MEMORANDUM

Topic: Final Approval of Proposed Standard N721
Internal Dosimetry Standards for Tritium

Comments on ANSI-N721 Standard

Internal Dosimetry Standards for Tritium

FIGURE 1 LONG TERM TRITIUM EXCRETION DATA (MOGHISSI 1978)

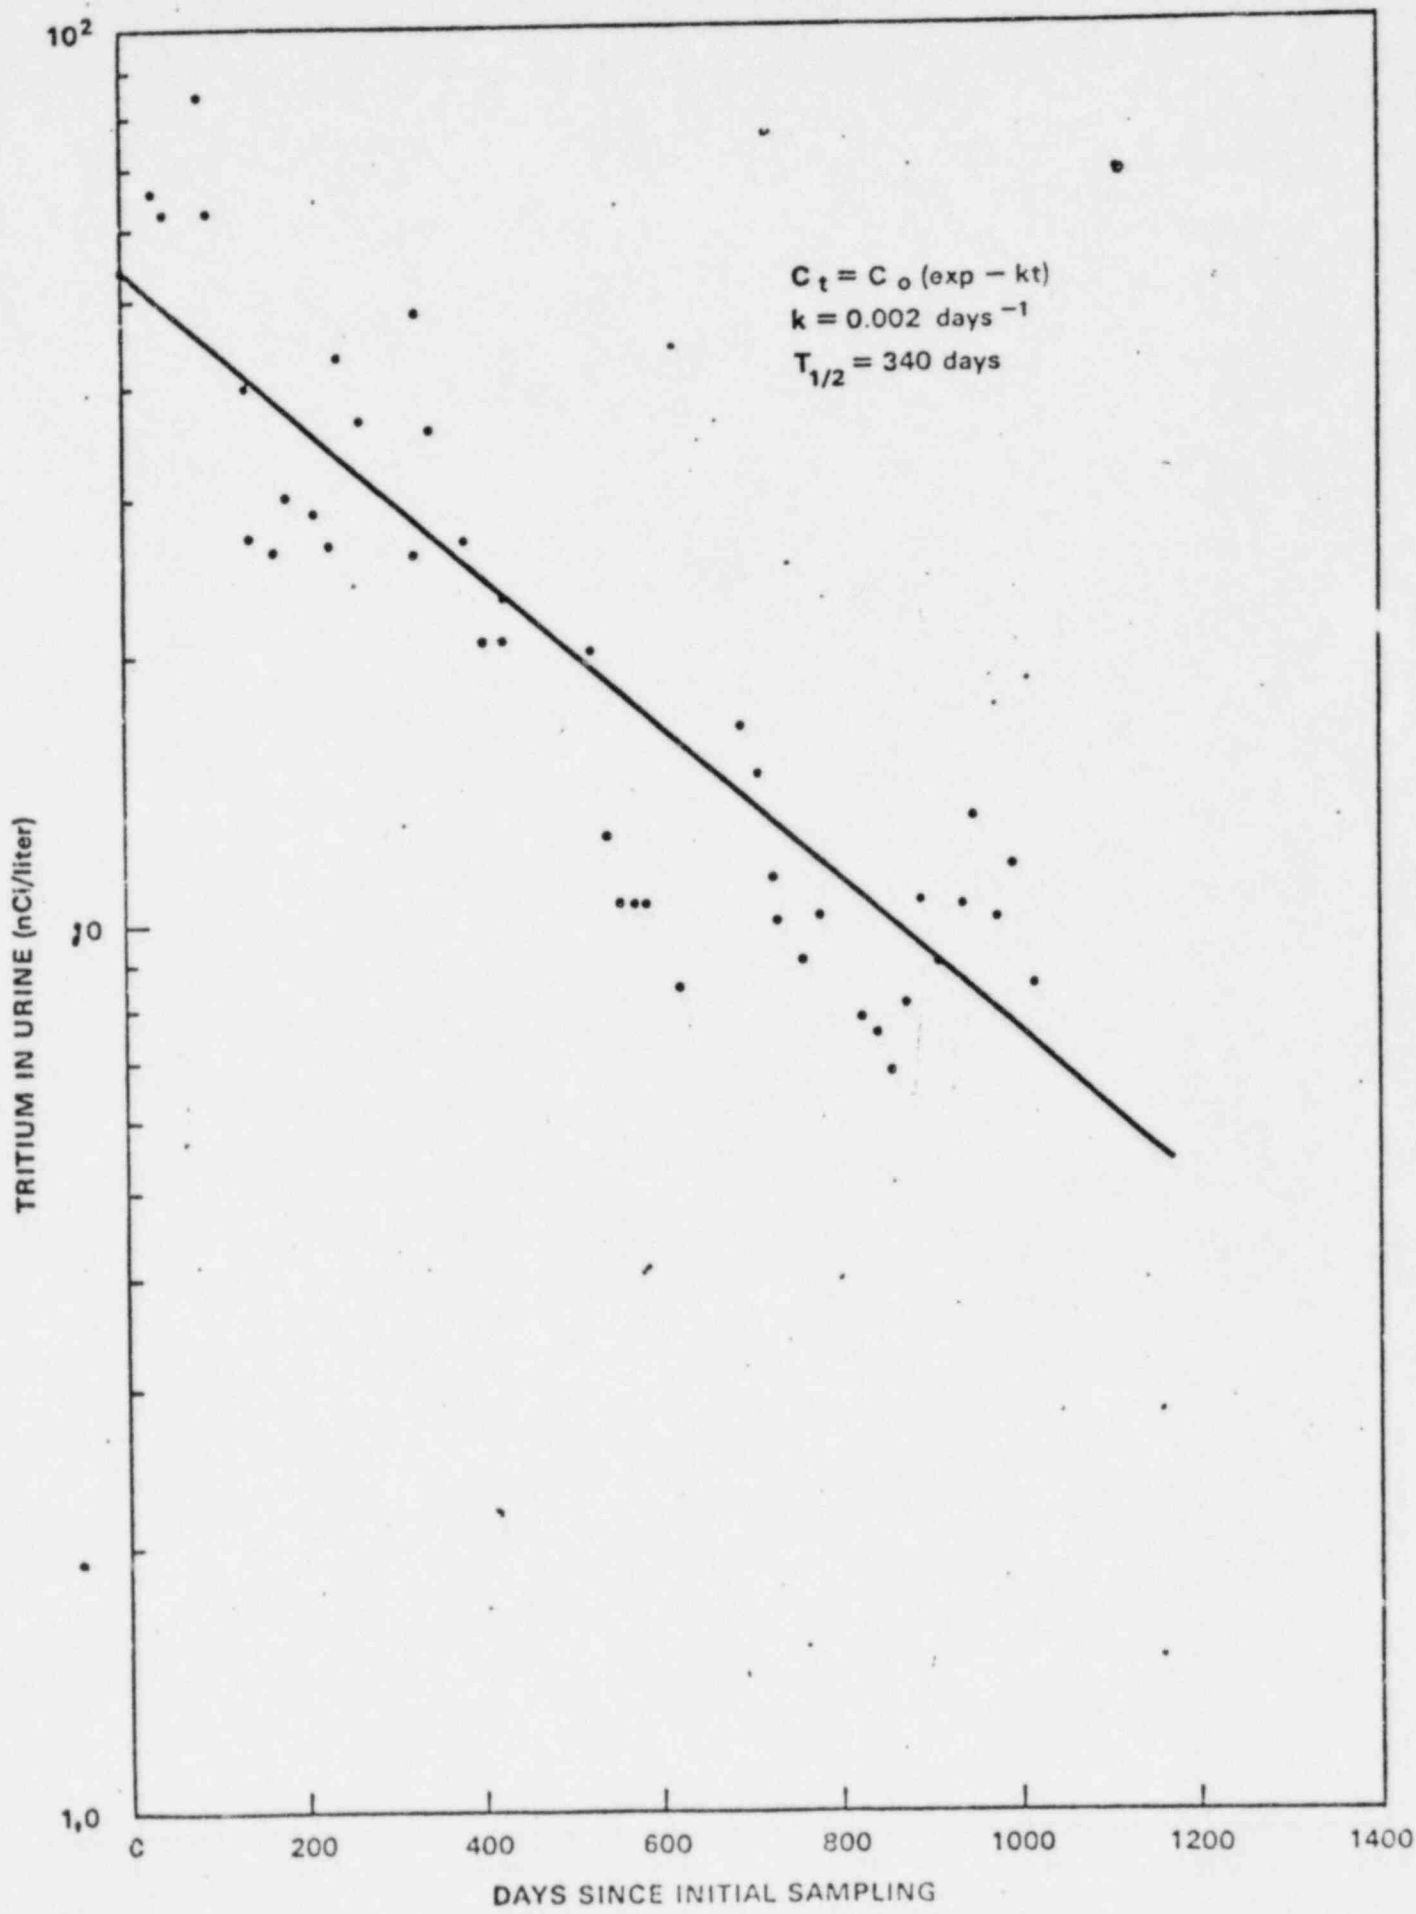
This section states that the previous radiation history of new employees will be reviewed and that this will include the results of new bioassay data. The kinetics given in Section 9.0, however, are not sufficient to evaluate dose commitments for some former tritium workers returning to the industry.

Figure 1 is a long-term tritium excretion curve from a former tritium worker. Sampling was initiated about six months following termination of employment. A specific activity model from the results of the first sample (0.055 uCi/l) would indicate a body burden of:

$$0.055 \text{ uCi/liter} \times 43 \text{ liters} = 2.4 \text{ uCi}$$

The actual body burden at t = 0 is, however, :

$$Q_3 = \frac{0.055 \text{ uCi/l} \times 3 \text{ l/day}}{0.002 \text{ day}^{-1}}$$

$$Q_3 = 83 \text{ uCi}$$

It was calculated in the previous section that this long-term component (Q₃) was associated with about 6.4 kg of tissue so that the time integrated unit weight concentration would be:

$$\frac{83 \text{ uCi} \text{ day}}{6.4 \text{ kg} \cdot 0.002} = 6500 \frac{\text{uCi} \cdot \text{day}}{\text{kg}}$$

This is significantly higher than if it were assumed that 2.4 uCi were distributed equally throughout 43 kg of water with a 10 day half-time:

$$\frac{2.4 \text{ uCi} \text{ day}}{43 \text{ kg} \cdot 0.0693} = 0.8 \frac{\text{uCi} \cdot \text{day}}{\text{kg}}$$

It is thus possible to underestimate a unit tissue dose by a factor of 8000 in this instance.
